DOOSAN Document Transmittal Upper Trishuli-1 HEP (216MW)		Date 2022-08-12	DT No.: UT1-HEP-DHI-PC-D-0057	SHEET 1 OF 1
DOOSAN NEPAL BRANCH OFFICE	Address & Contact No. : Four Square Building, Naxal, Kathmandu, Nepal (P.O Box : 1387) + 977 1 692 3014	Project No. H20002	DOCUMENT DISPATCHED BY Courier Service ☐ Messenger ☐ Post-Air Freight ☐ Document System or E-mail ■ By hand ■	
DOCUMENT DISTRIBUTION	■ POWER CHINA (Subcontractor) ☐ Doosan's Site Office			
SUBJECT	Review Note RN-0215_Layout DWG of Desander Basin

REVIEW NOTE

Contractor	**Doosan Enerbility**		
Title of the Document	Layout Drawing of Desander Basin		
Document/Drawing No.	UT1-C-030-CVL-DG-52001	Revision	0B
Date of Documents/Drawings	28.07.2022	Received Date	01.08.2022
Transmittal Form No.	UT1-HEP-DHI-D-0329		
Previous Review Date/Status	20.10.2021/RR	Prev. Review Note No.	RN-0019
Review Note No.	**RN-0215**	**Present Review Date**	**12.08.2022**
		Present Review Status	**AN**

DRAWING TITLE
LAYOUT DRAWING OF DESANDER BASIN

PLAN LAYOUT OF DESANDER BASIN

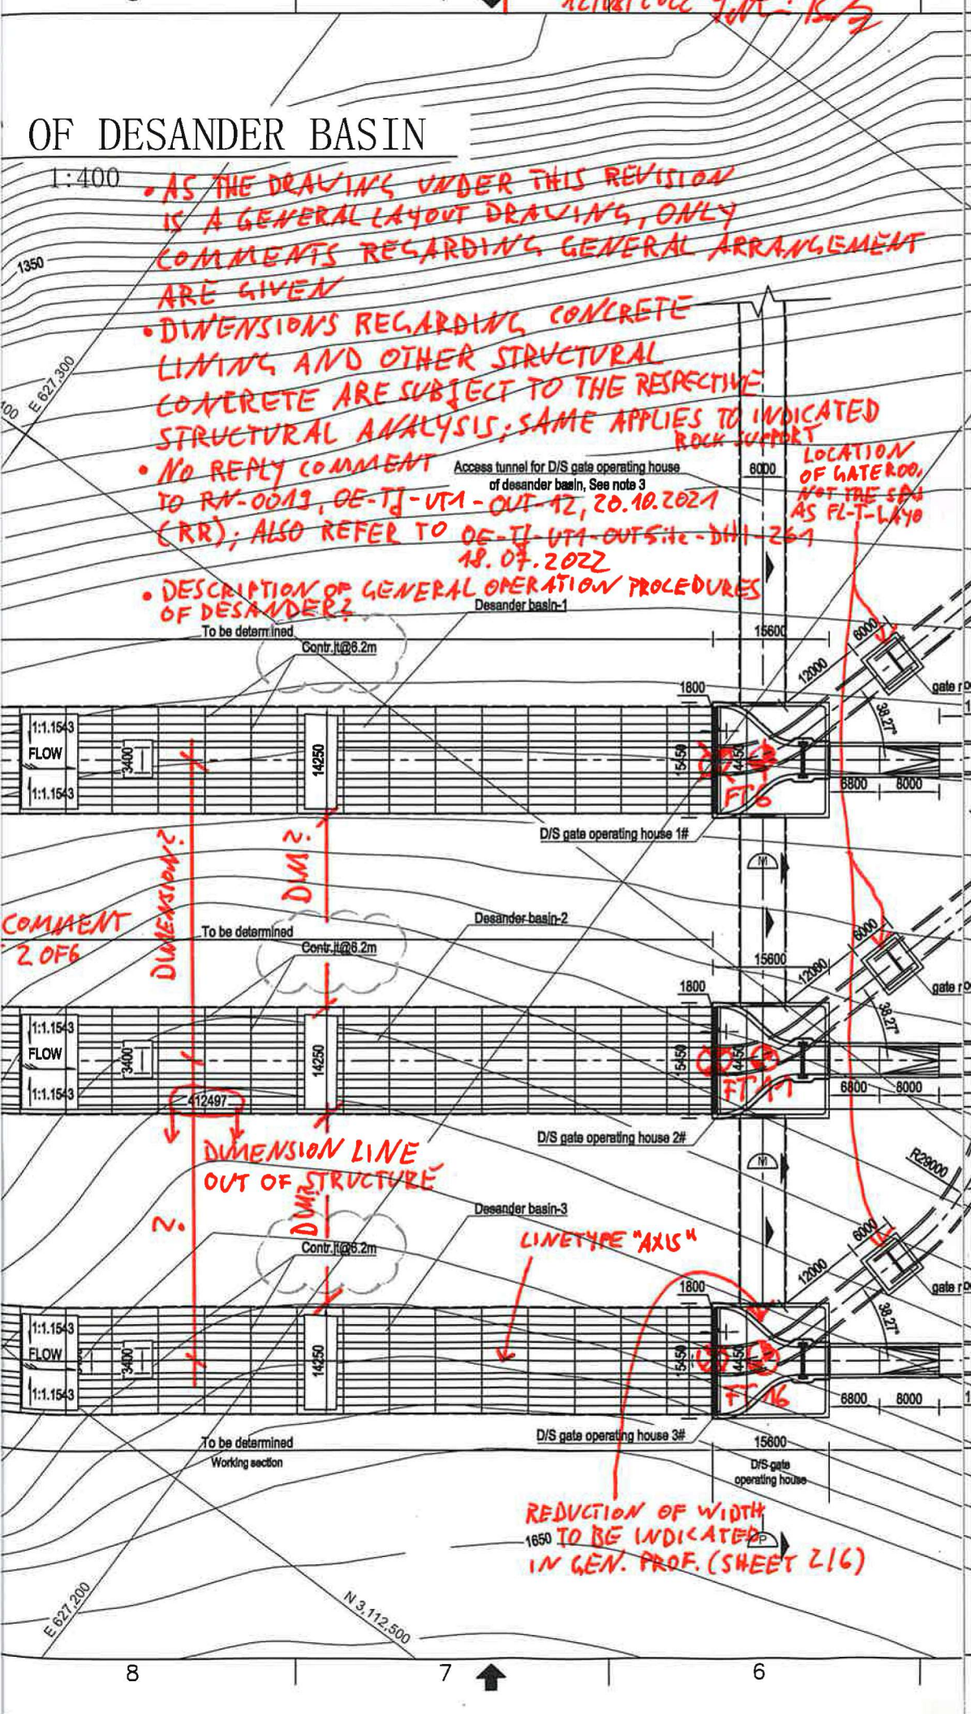
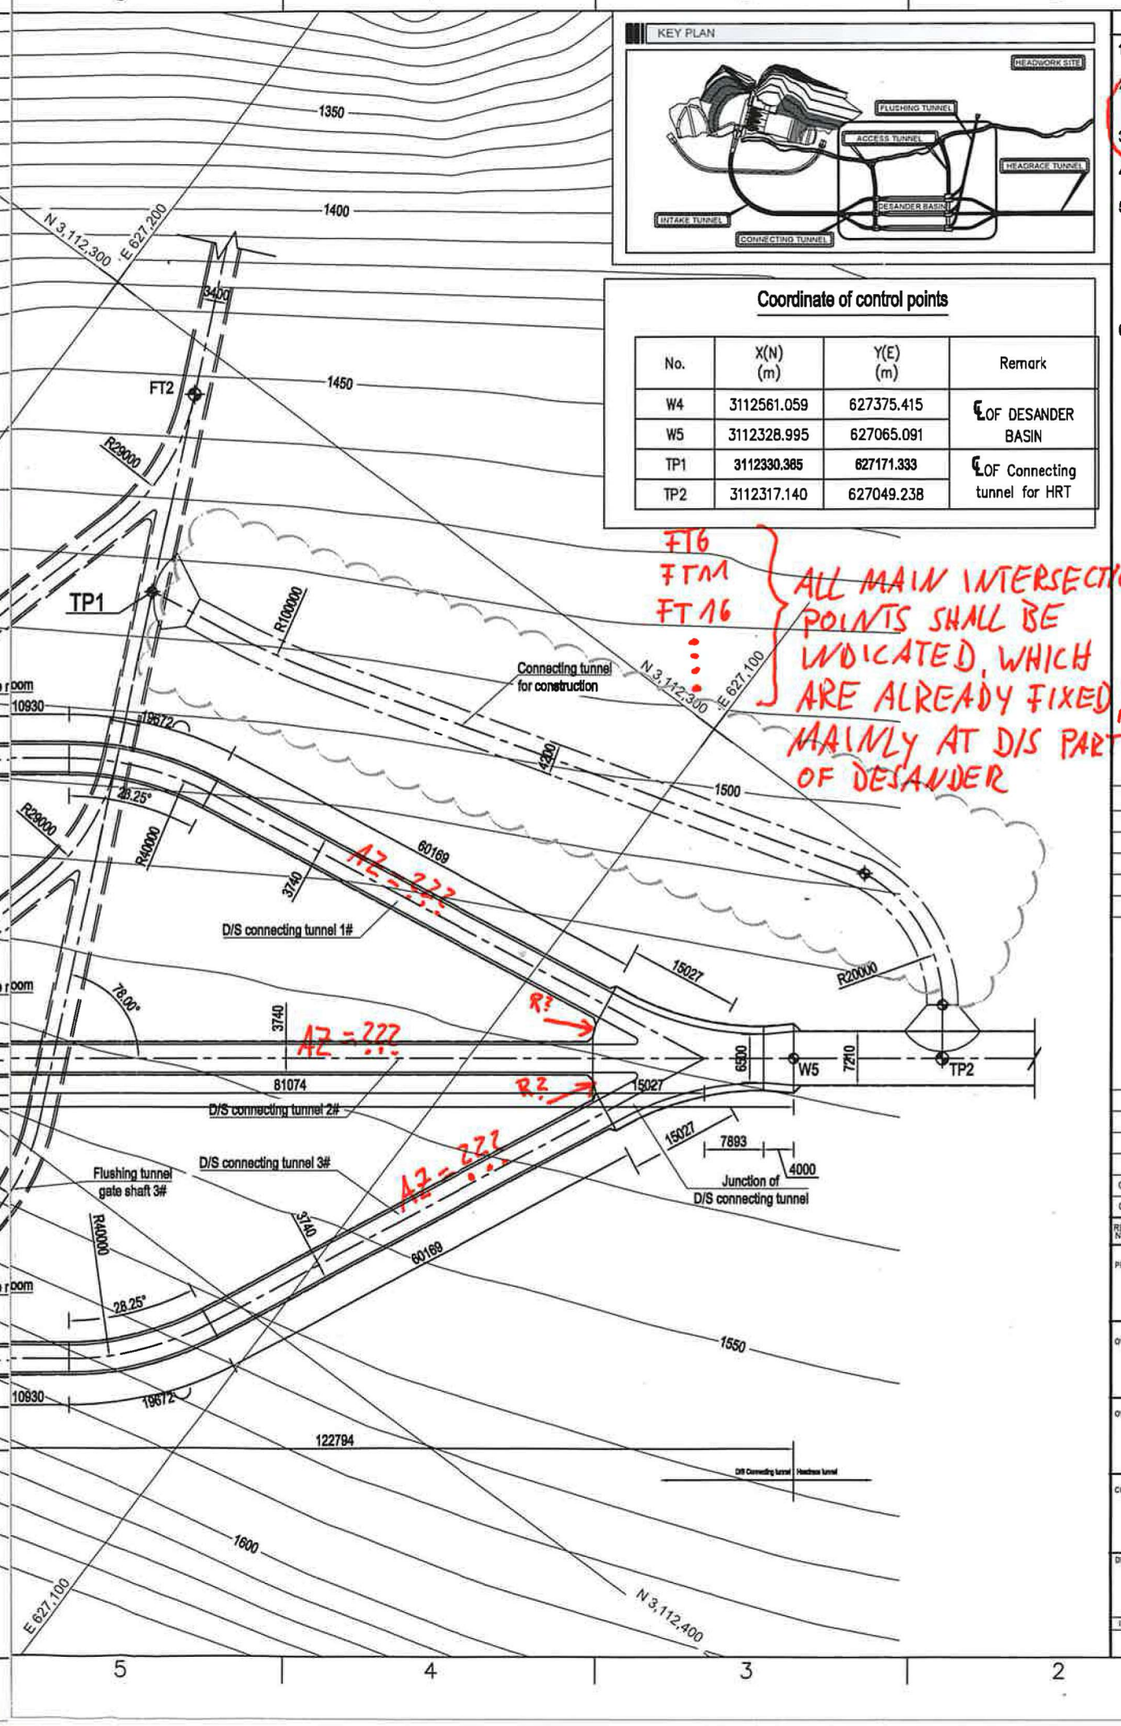
- HYDROMECHANICAL EQUIPMENT, TRANSPORTATION AND INSTALLATION NEEDS TO BE CONFIRMED BY THE RESPECTIVE SUPPLIER AS WELL AS ALL OTHER NECESSARY E&M EQUIPMENT
- FINAL APPROVAL IS SUBJECT TO RESULTS OF OUTSTANDING NUMMERICAL ANALYSIS (BESIDE OTHERS)
- ACCESSTUNNELS FOR U/S AND D/S DESANDER GATE CHAMBERS, FLUSHING TUNNEL, CONNECTING TUNNEL ARE SUBJECT TO SEPARATE REVIEW NOTES
- AZIMUTH OF AXIS NOT INDICATED
- ALL STRUCTURS WITH THEIR DIMENSIONS AND AXIS SHALL BE PRECISELY MATCHED BETWEEN ALL CORRESPONDING ACCOMPANING DESIGN DOCUMENTS (→ DRAWINGS, STRUCTURAL ANALYSIS, REPORTS, METHOD STATEMENTS, ETC.)
- LOCAL GRID SHALL BE DEFINED AND INDICATED IN ALL DESIGN DRAWINGS
- COMMENTS ARE VALID FOR ALL 6SHEETS OF THE DRAWING UNDER THIS REVISION

- AS THE DRAWING UNDER THIS REVISION IS A GENERAL LAYOUT DRAWING, ONLY COMMENTS REGARDING GENERAL ARRANGEMENT ARE GIVEN
- DIMENSIONS REGARDING CONCRETE LINING AND OTHER STRUCTURAL CONCRETE ARE SUBJECT TO THE RESPECTIVE STRUCTURAL ANALYSIS; SAME APPLIES TO INDICATED ROCK SUPPORT
- NO REPLY COMMENT TO RN-0013, OE-TJ-UT1-OUT-12, 20.10.2021 (RR); ALSO REFER TO OE-TJ-UT1-OUT-SITE-DH1-261 18.07.2022
- DESCRIPTION OF GENERAL OPERATION PROCEDURES OF DESANDER?

SUBJECT TO FINAL APPROVAL OF NUMERICAL ANALYSIS

AZ = ???

R?

NOT BIFURCATION BUT TRIFURCATION

DIMENSION LINE OUT OF STRUCTURE

LINETYPE "AXIS"

REDUCTION OF WIDTH TO BE INDICATED IN GEN. PROF. (SHEET 2/6)

LOCATION OF GATEROOM NOT THE SAME AS FL-T-LAYO

LOCATION OF GATE ROOM, NOT THE SAME AS PL-T-LAY0

ALL MAIN INTERSECTION POINTS SHALL BE INDICATED, WHICH ARE ALREADY FIXED, MAINLY AT D/S PART OF DESANDER

GENERAL PROFILE OF DESANDER BASIN

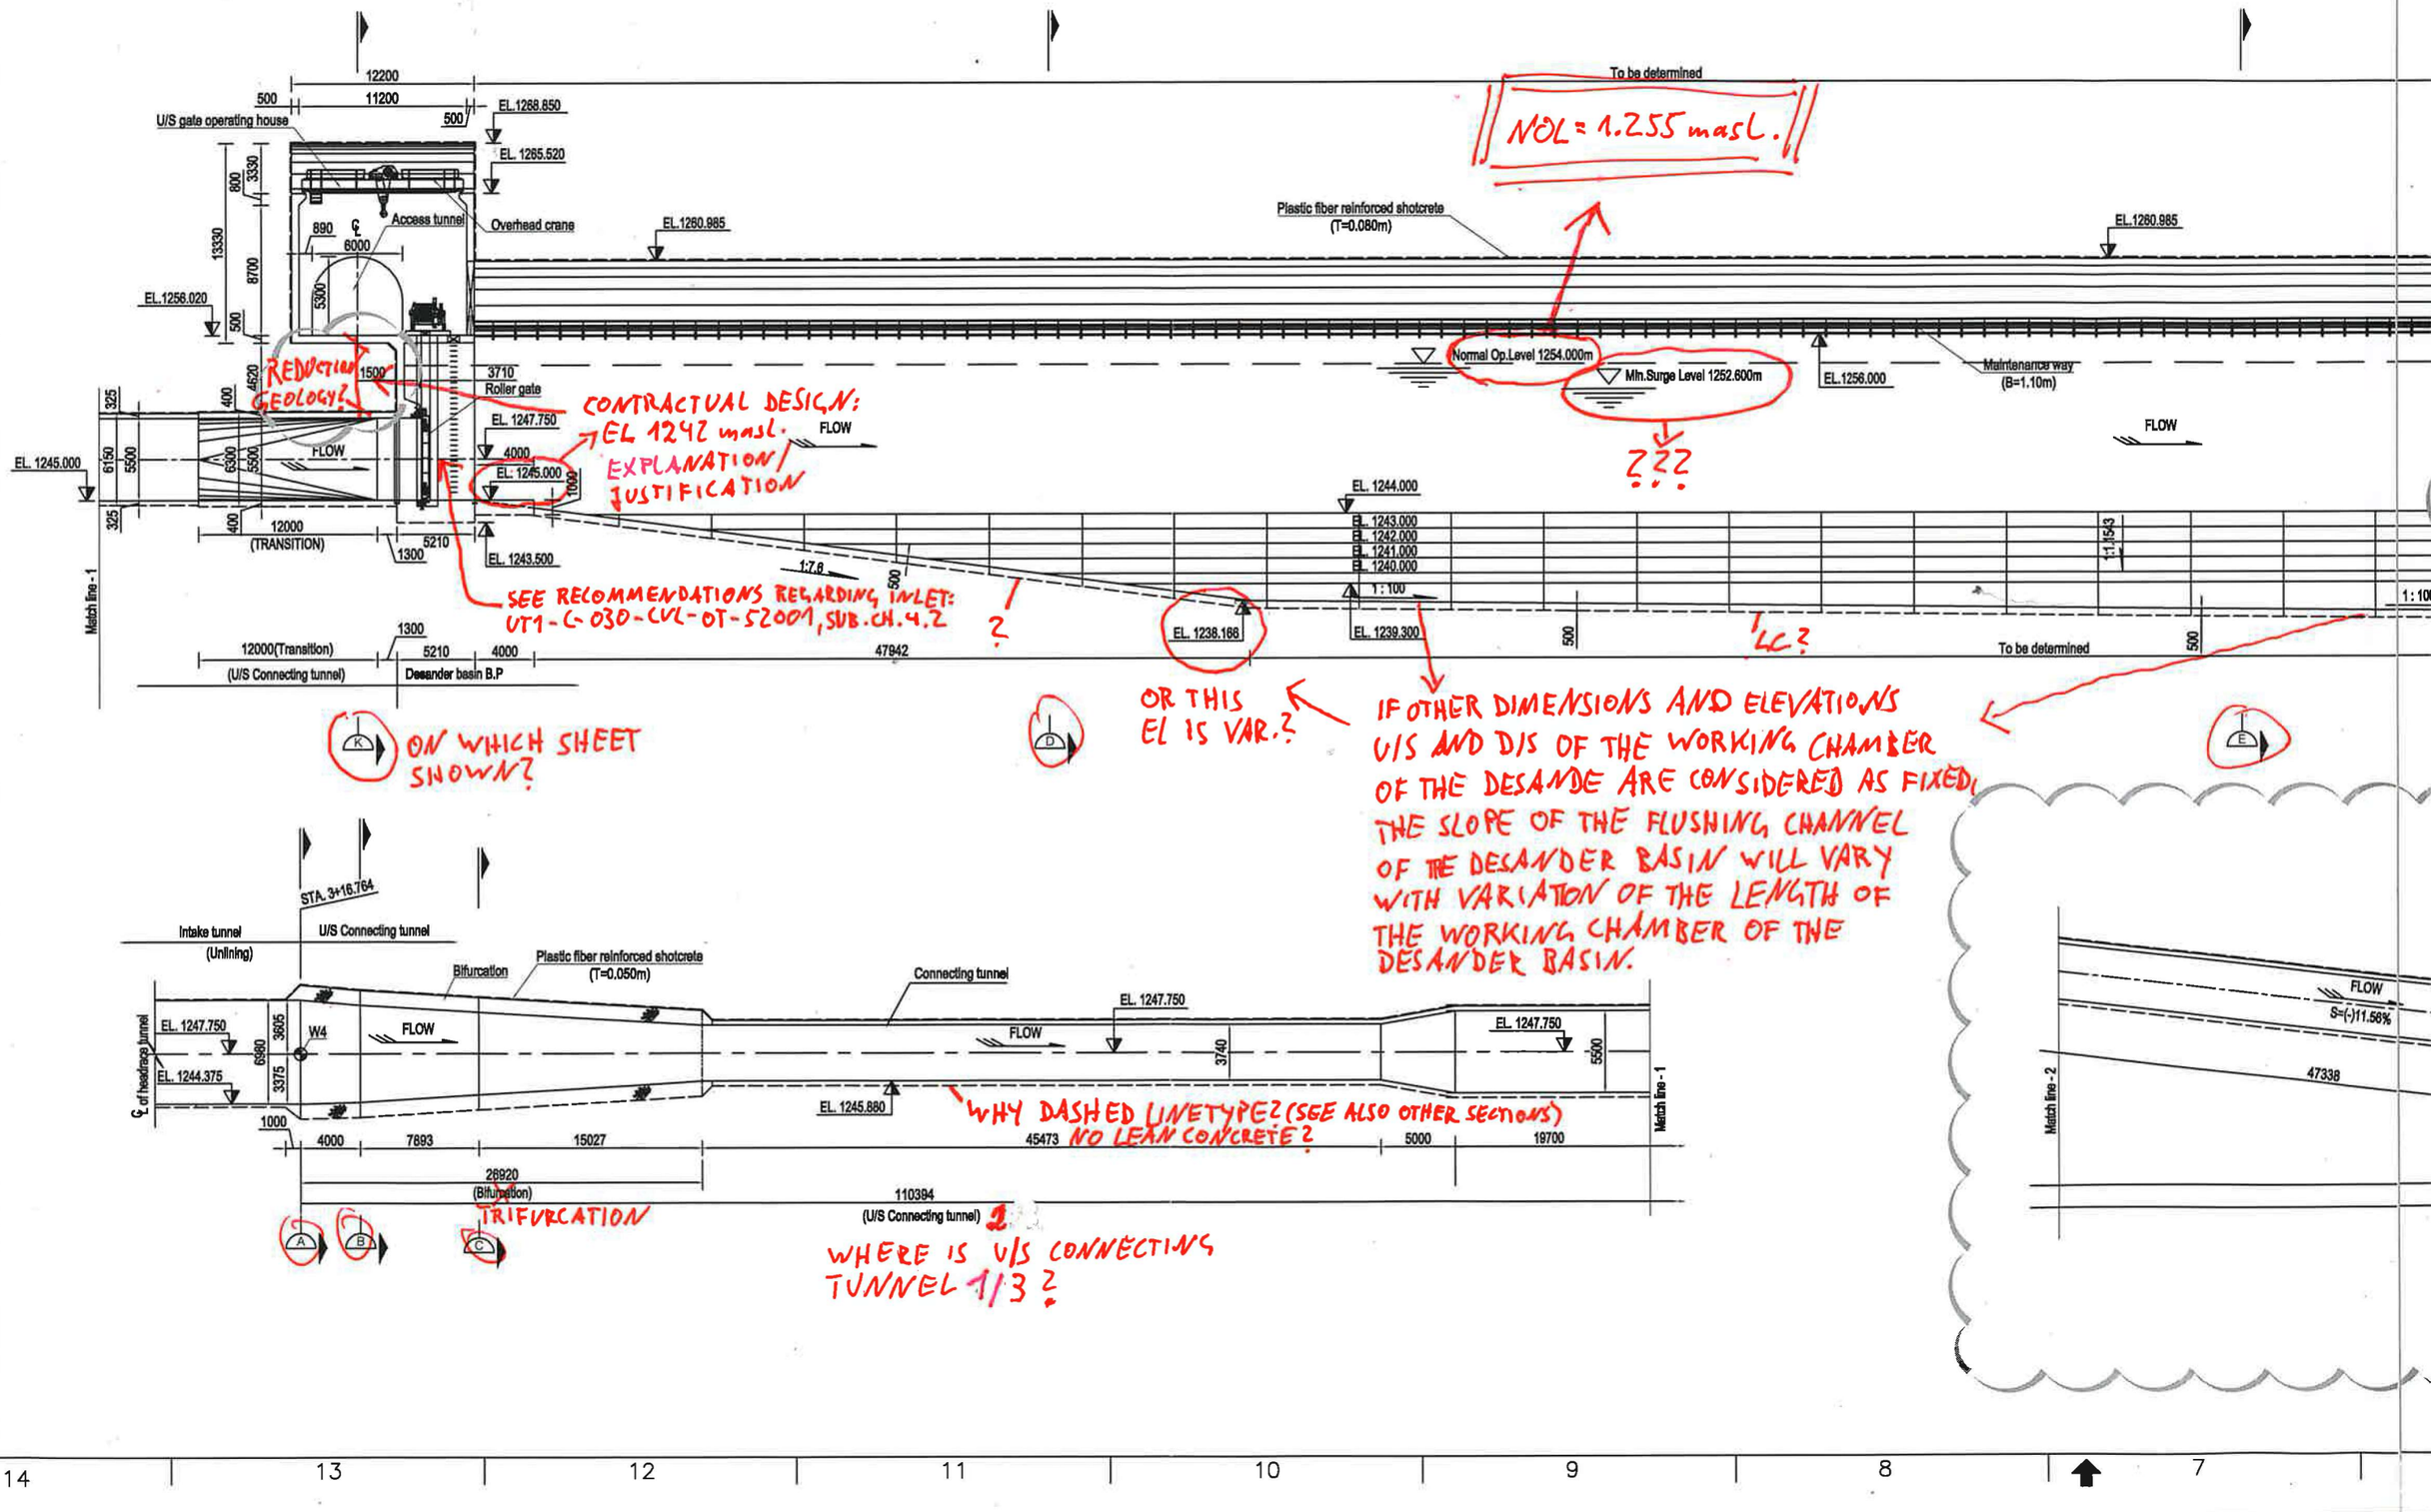
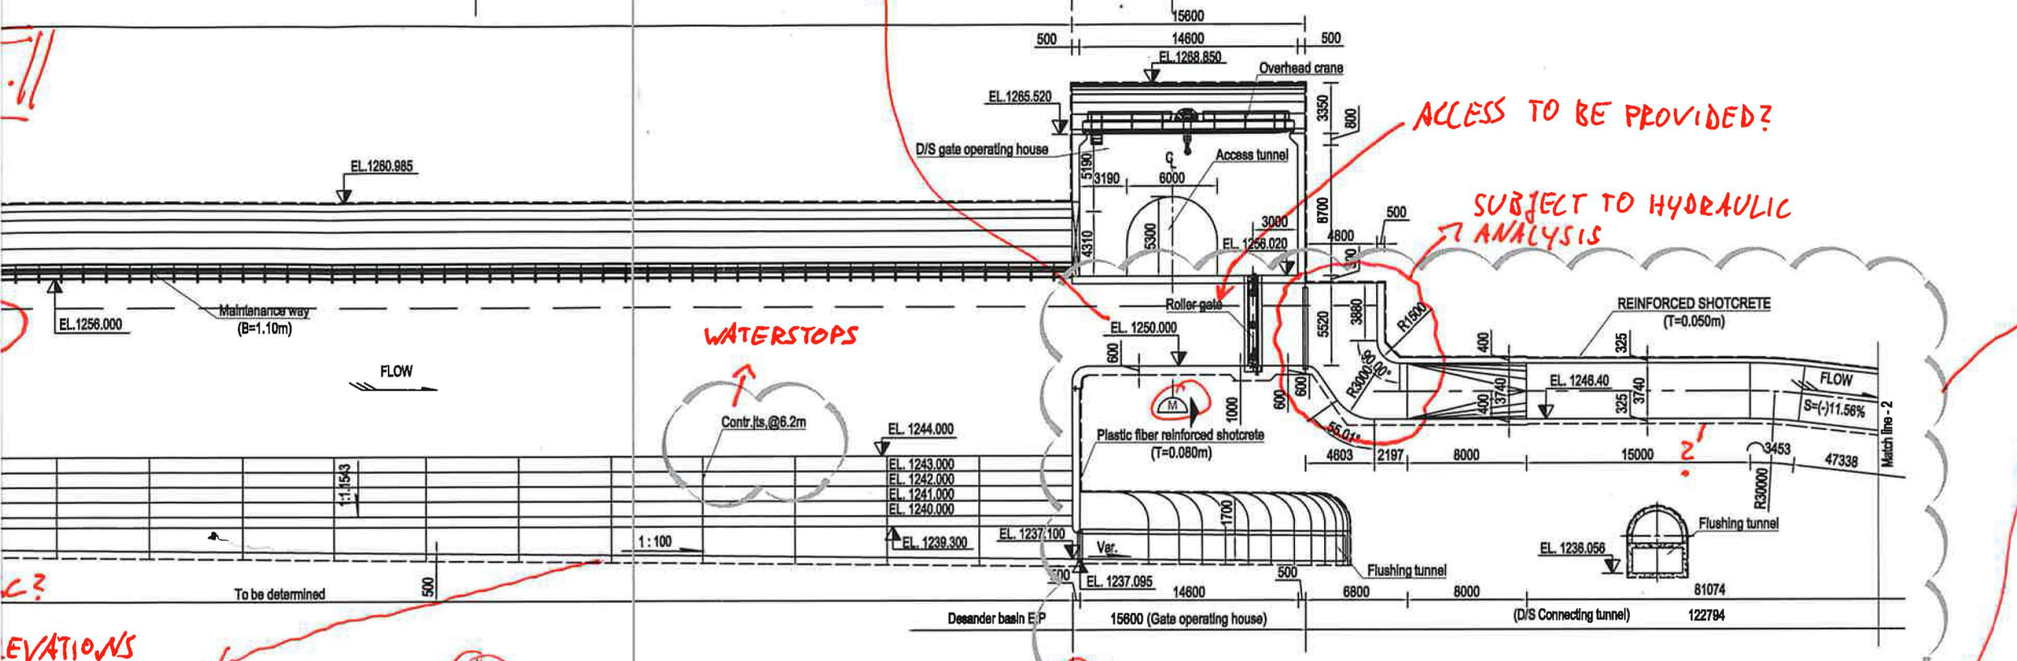
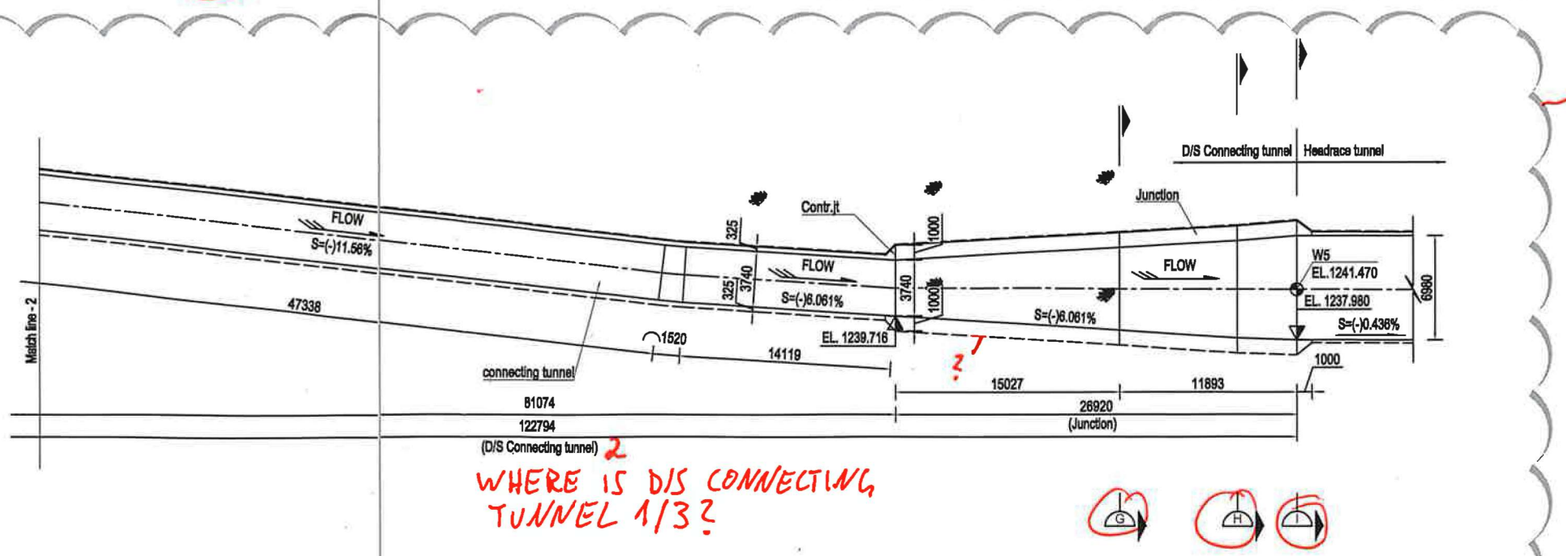
REDUCTION OF WIDTH AS SHOWN IN PLAN LAYOUT (SHEET 1/6) SHALL BE INDICATED

ACCESS TO BE PROVIDED?

SUBJECT TO HYDRAULIC ANALYSIS

WATERSTOPS

REVISIONCLOUD INDICATES WHAT? CHANGE FROM REV04 TO REV05?

WHERE IS D/S CONNECTING TUNNEL 1/3?

SECTION F-F
1:100

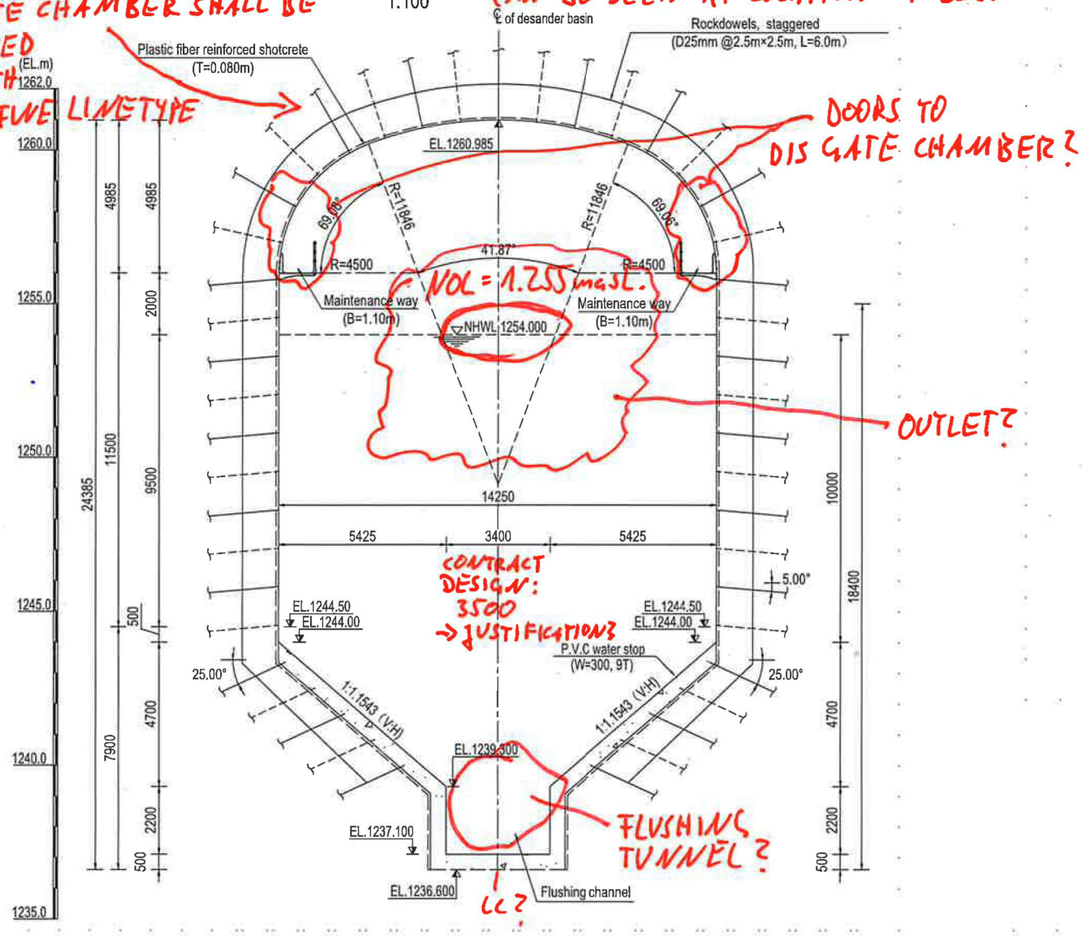
OUTLINE OF HIDDEN DIS GATE CHAMBER SHALL BE INDICATED E.G. WITH DASHED FINE LINETYPE

NOT INDICATED AS CAN BE SEEN AT LOCATION OF SEC. F-F

DOORS TO DIS GATE CHAMBER?

OUTLET?

CONTRACT DESIGN: 3500 → JUSTIFICATION?

FLUSHING TUNNEL?

LC?

SECTION G-G
1:100

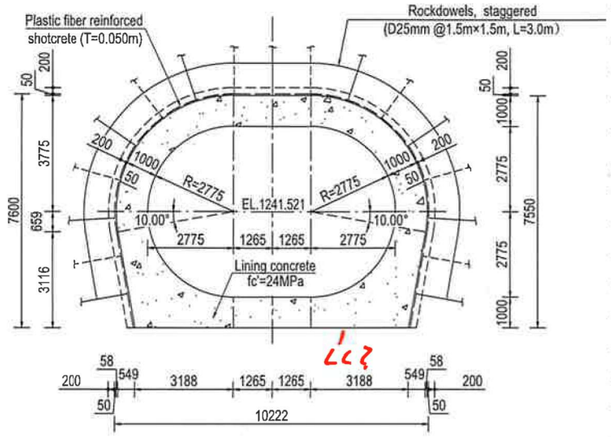
LC?
